Cambridge Waste Water Treatment Plant Relocation Project  
Anglian Water Services Limited

# Applicant's Responses to the Examining Authority's Written Questions

Application Document Reference: 8.3  
PINS Project Reference: WW010003  
APFP Regulation No. n/a

Revision No. 01  
November 2023

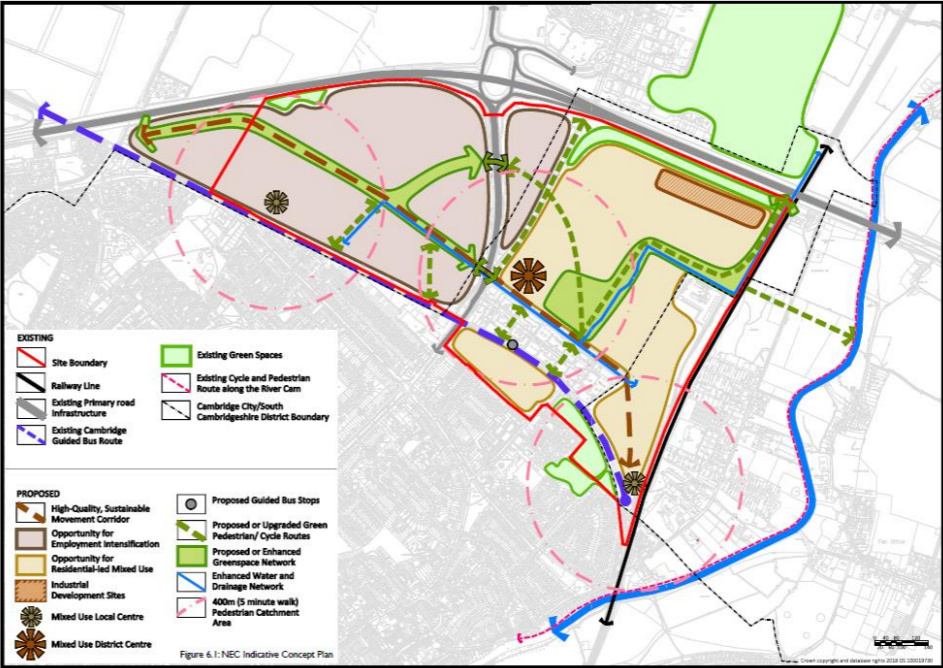
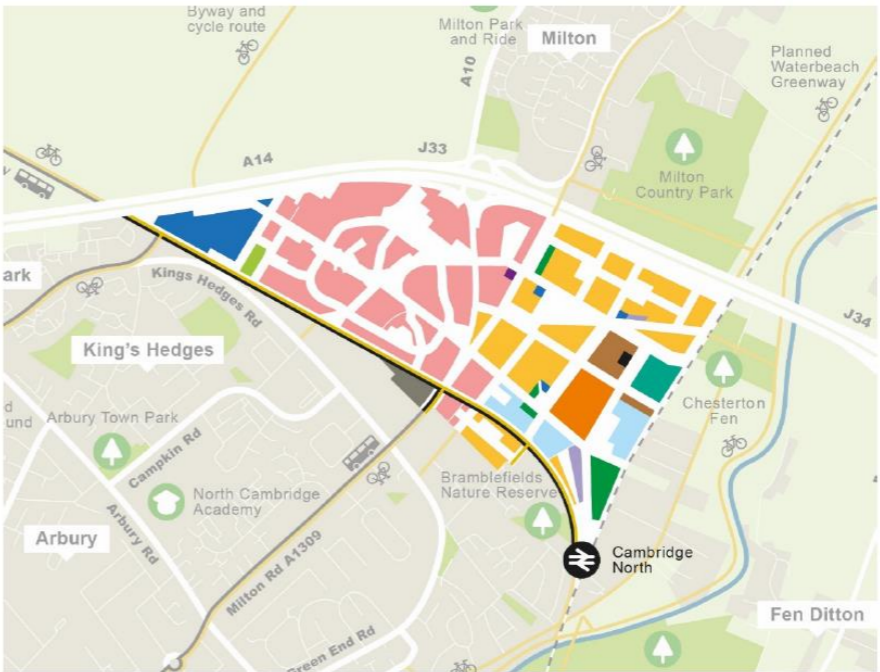
2.31	Applicant, CCC, SCDC	<p><b>Emerging local plan and draft NECAAP</b></p>

ExQ1	Question to	Question	Response																																																																																																								
			<p>Figure 45 and 46 below provide a summary of the broad distribution and phasing of the housing provision anticipated in the plan.</p>

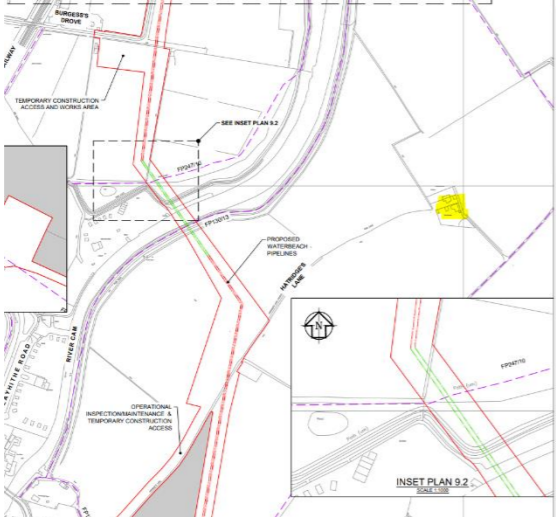
17.15	Applicant	<p><b>Proposed WWTP – use of excavated material</b> CCoC's RR [RR-001] states at 10.1 that <i>The Council notes that a quantity of material will be excavated from the ground to construct the proposed Transfer Tunnel and that this will be used in landscaping around the proposed Water Recycling Centre. During the Examination the Council will be seeking to ensure that only material from the development is used in the landscaping and that inert material</i></p>	<p>The Applicant notes that paragraph 4.2.9 of ES Chapter 16: Material Resources and Waste (App Doc Ref 5.2.16) [APP-048] states that 'based on the volume of material required for the proposed earth bank, as a worst-case scenario, there will be a deficit of 4,373 m<sup>3</sup> of material that will need to be imported, which is 1.65% of the estimated volume of fill material required for the proposed earth bank. It has been stated under Table 2-5 of ES Appendix 16.1 Material Resource Requirements and Waste Estimates (App Doc</p>

ExQ1	Question to	Question	Response
		<p><i>from other developments will not be required. If this were to occur it would change the policy context, and Policy 26 Other Developments Requiring Importation of Materials would be relevant. The Council wishes to ensure that the importation of inert material will not be required.</i></p> <p>Please explain whether and how CCoC's request can be addressed.</p>	<p>Ref 5.4.16.1) [APP-132] that: "The numbers provided indicate a minor shortfall in the volume required for the earth bank. As the intention is a 'cut fill balance' there would be minor adjustments in earthworks to achieve this intention, as a worst case however the import of material for this shortfall is considered in the assessment." The principles of design and construction of the Proposed Development are to achieve a cut fill balance so that the Proposed Development does not require importation of inert material. If the final design requires the import of small volume of inert material, then a consultation will be undertaken with CCoC to identify and agree the approach to mitigate potential effects from the importation of material.</p> <p>The Applicant refers to measures relating to the reuse of materials within the Proposed Development as set out within section 7.9 of the CoCP Part A (App Doc Ref 5.4.2.1) [APP-068], which requires the implementation of an approved Materials Management Plan.</p>
